# Rezoning Transportation Analysis

Petition Number: 2017-077

General Location Identifier: 067-045-16

## General Review Information

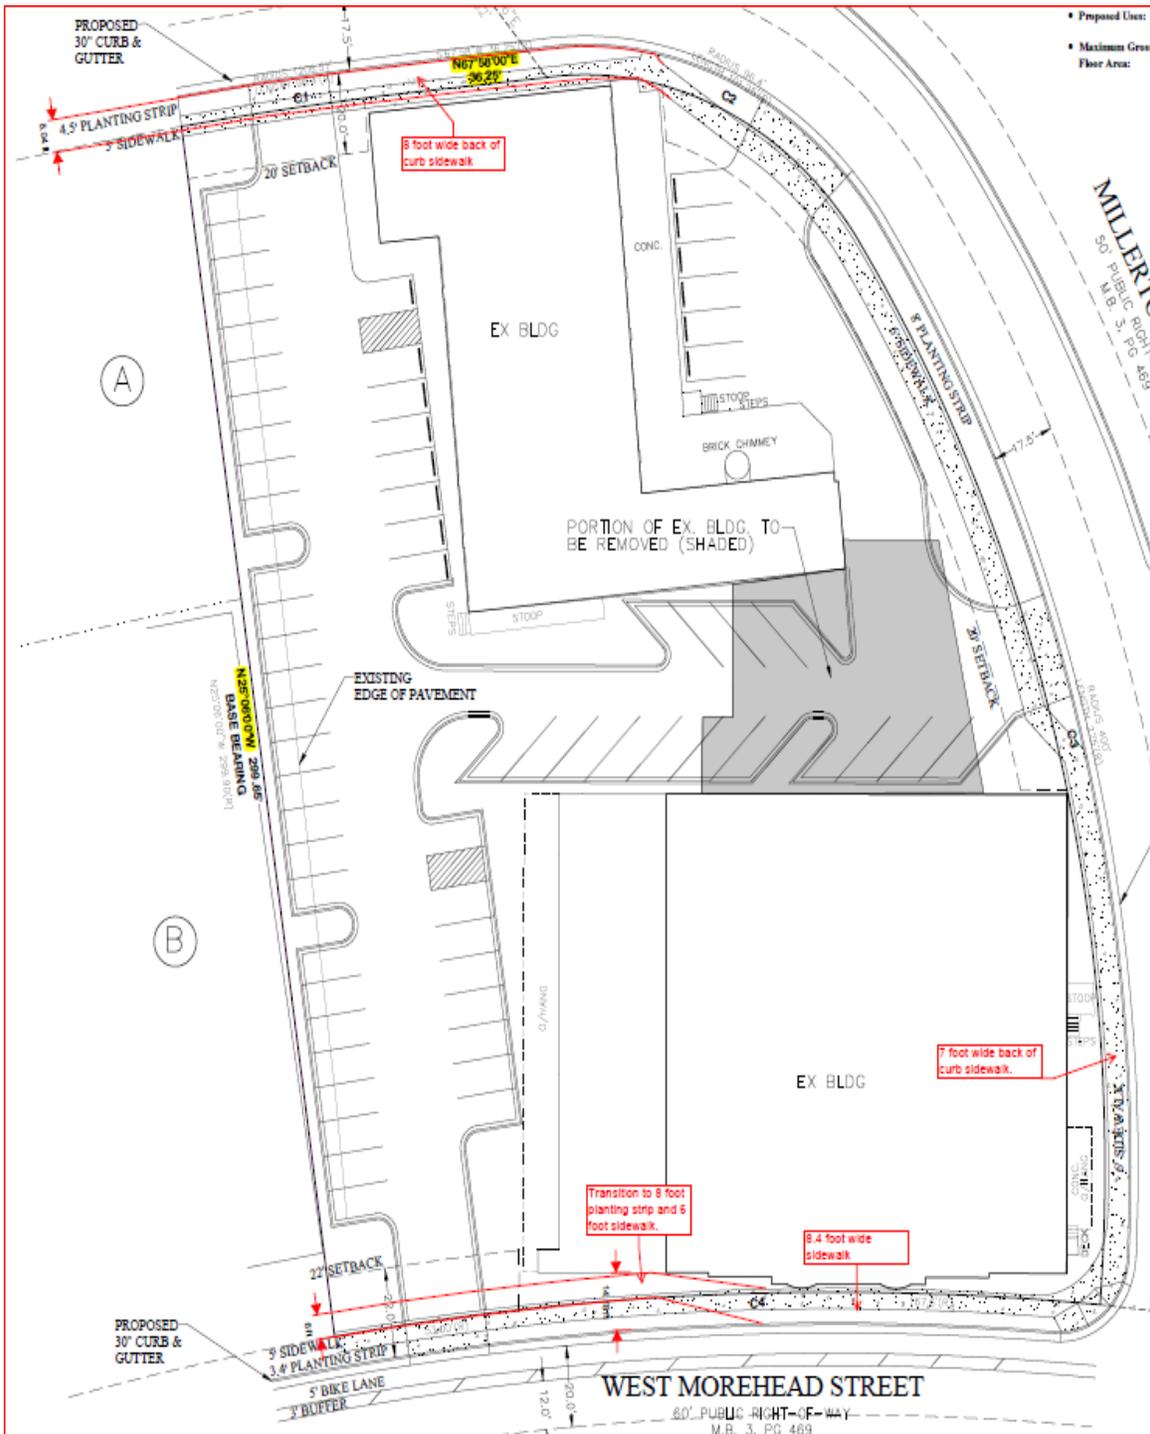
- The petitioner should revise the site plan to show standard 8' planting strip and 6' sidewalk along as much of the site's public street frontage as possible (i.e. add along eastern portion of Morehead frontage) and 8' back of curb sidewalk in areas where existing buildings do not allow the standard section. Additional pinch points (but no less than 7' back of curb sidewalk) can be detailed during permitting. Petitioner should also consider planting strip behind sidewalk along areas where back of curb sidewalk is needed. Use sketch below as a guide.
